**RE: PROPOSED PRIVATE PLAN CHANGE – RFI RESPONSES**  
**100 HOBSONVILLE ROAD, HOBSONVILLE**

Appended to this cover letter are CMW's Geotechnical responses to specific items raised by Auckland Council following the submission of CMW Geotechnical Assessment Report, reference AKS2023-0062AB Rev 0, dated 30 November 2023, in support of a proposed private plan change (PPC).

Appendix A: Table 1 RFI Responses

CLIENT: AUSTINO PROPERTY GROUP	DRAWN: FK	PROJECT: AKS2023-0062
PROJECT: 100 HOBSONVILLE ROAD, HOBSONVILLE	CHECKED: EC	DRAWING: 01
TITLE: GEOMORPHOLOGICAL PLAN	REVISION: Rev 1	SCALE:
	DATE: 30/07/2024	SHEET: A3 L

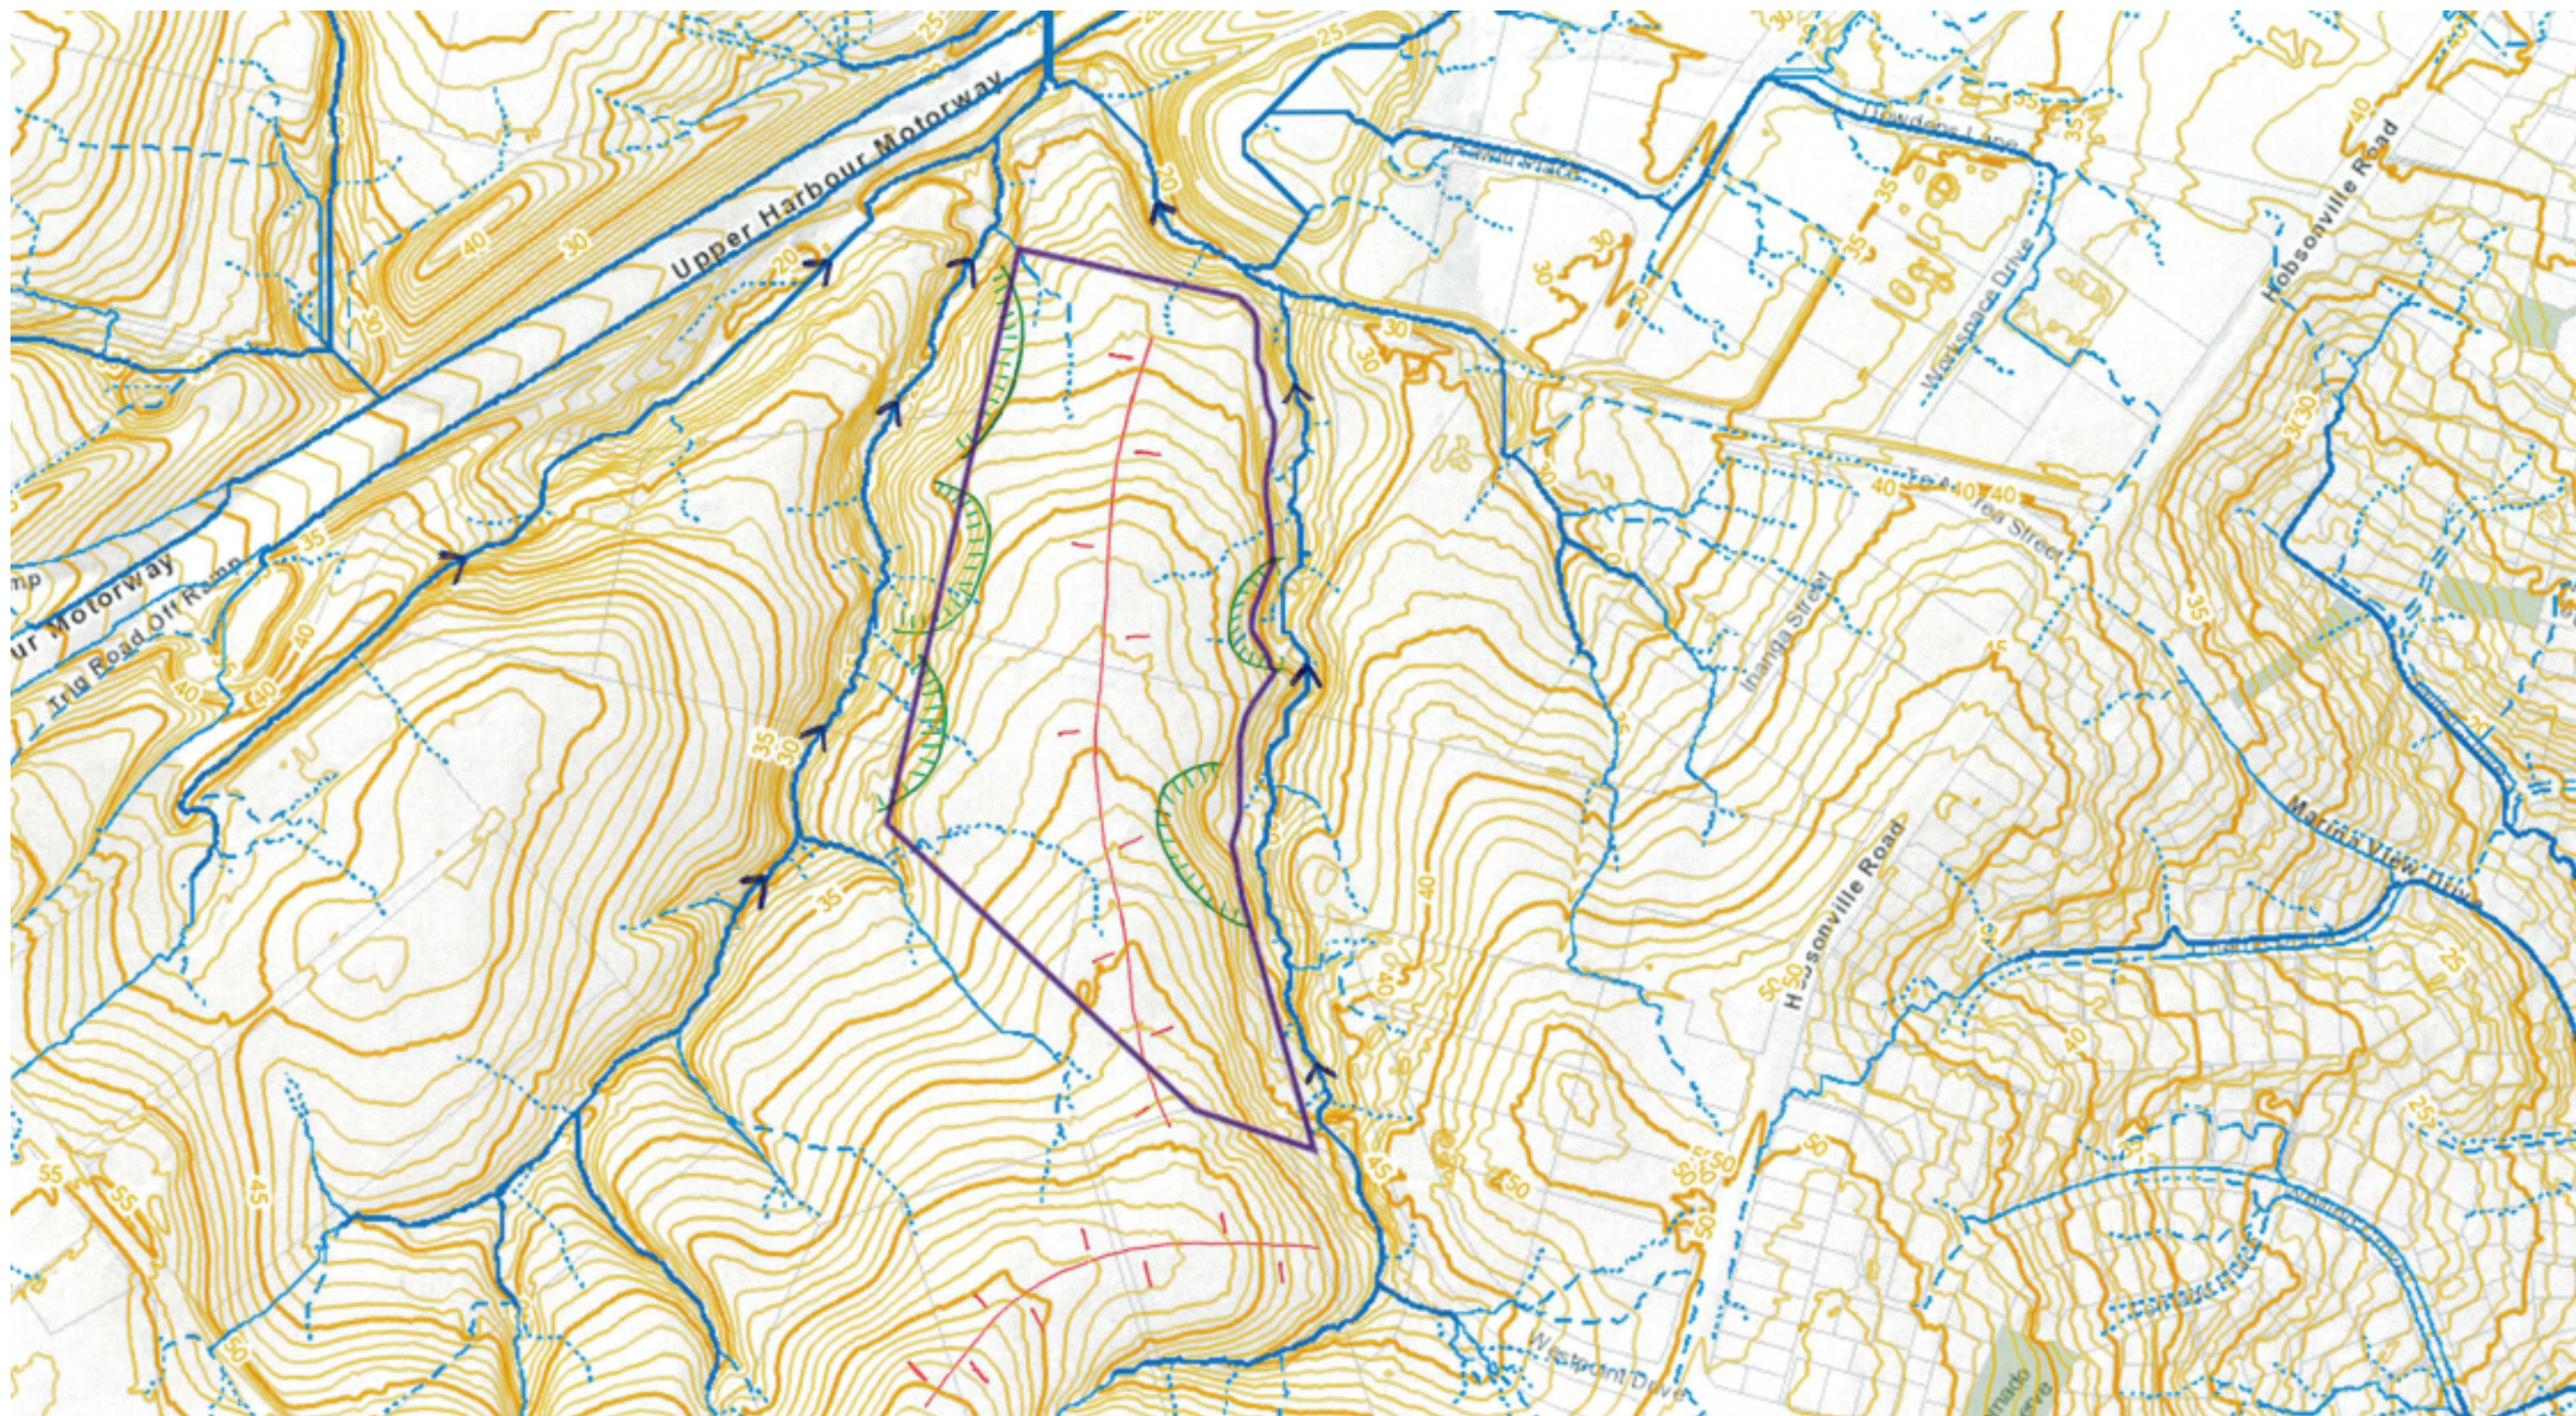
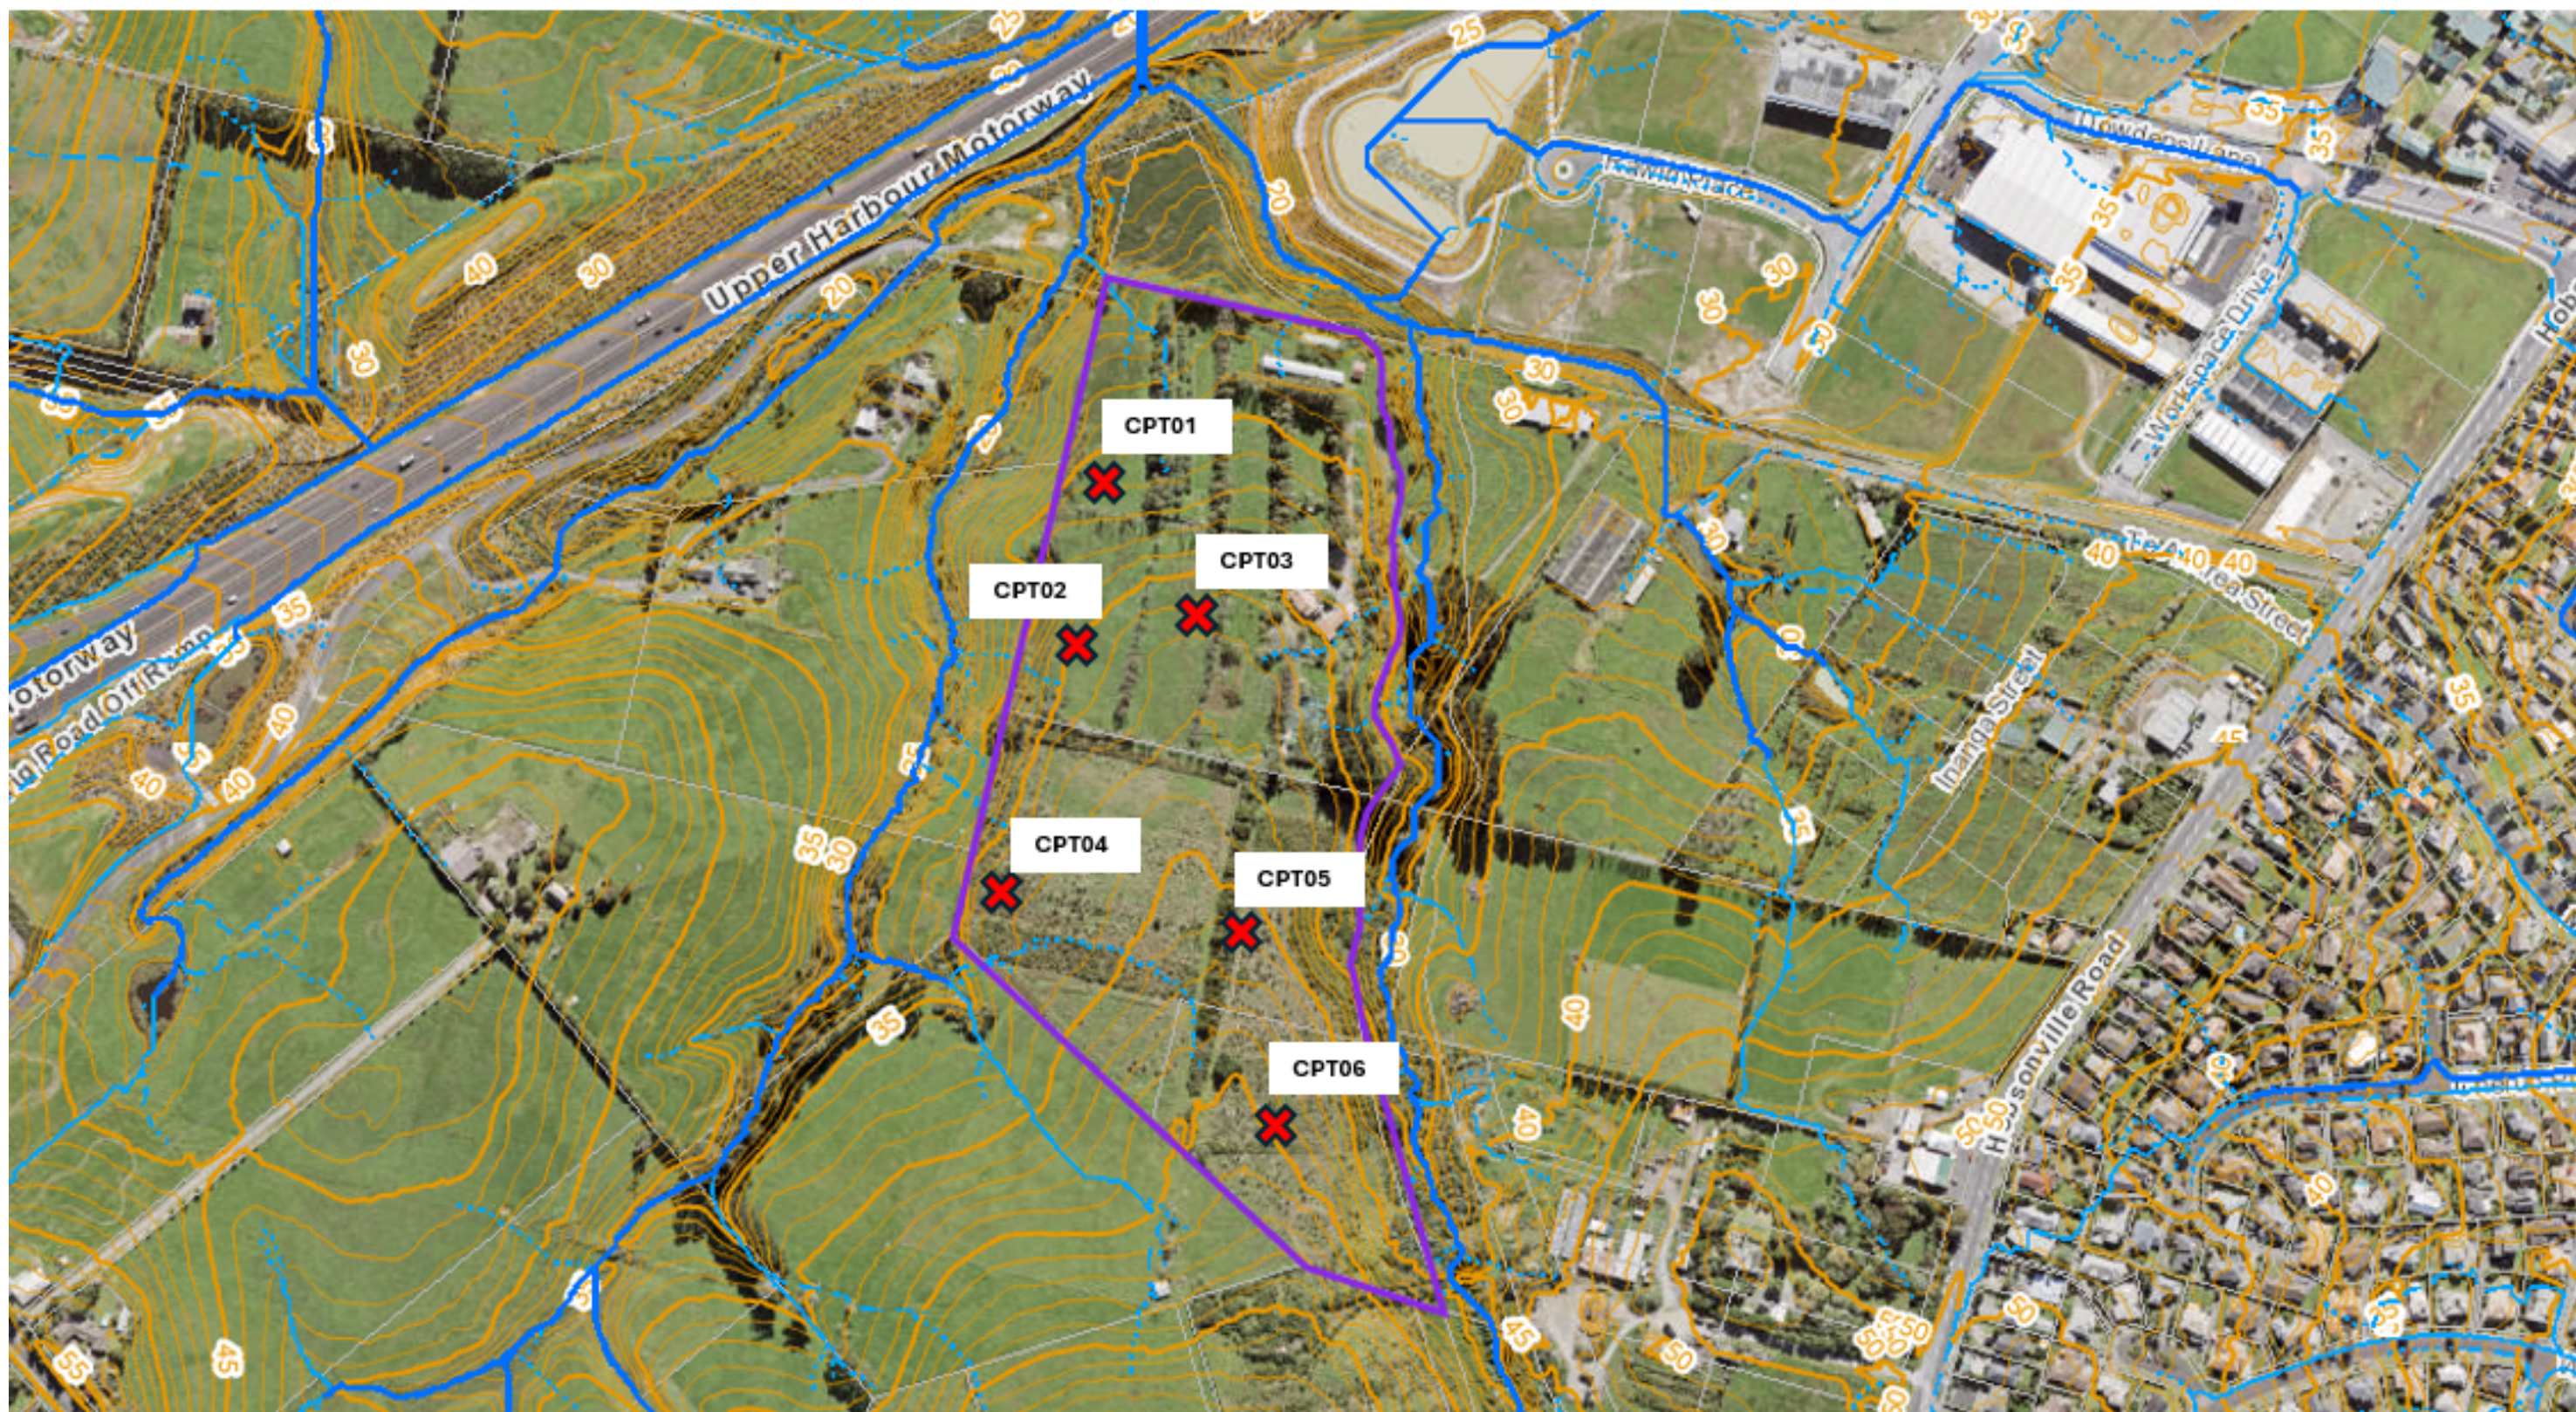
G3	Please confirm if the site walkover and geomorphological mapping have been undertaken by an engineering geologist. If so, please provide supporting information. If not, please carry out these exercises and provide the required information.	We can confirm that a site walkover was undertaken by an experienced Geologist and there were no additional geomorphological features identified when compared with the aerial photographs. The observations made on site in conjunction with the previous desktop study are presented on the appended geomorphological map in Appendix B.
G4	Please provide a geomorphological map for the site.	See response G3 above.
G5	Please re-assess the liquefaction vulnerability and update Section 5 accordingly	6 CPT tests were undertaken in the locations identified on the site plan attached in Appendix C to assess site-specific liquefaction susceptibility The methodology of assessment and results are presented in Appendix D which confirms that the risk of Liquefaction Potential is low as well as the Probability of Liquefaction is also low. These results are in keeping with the assessment in the GAR.
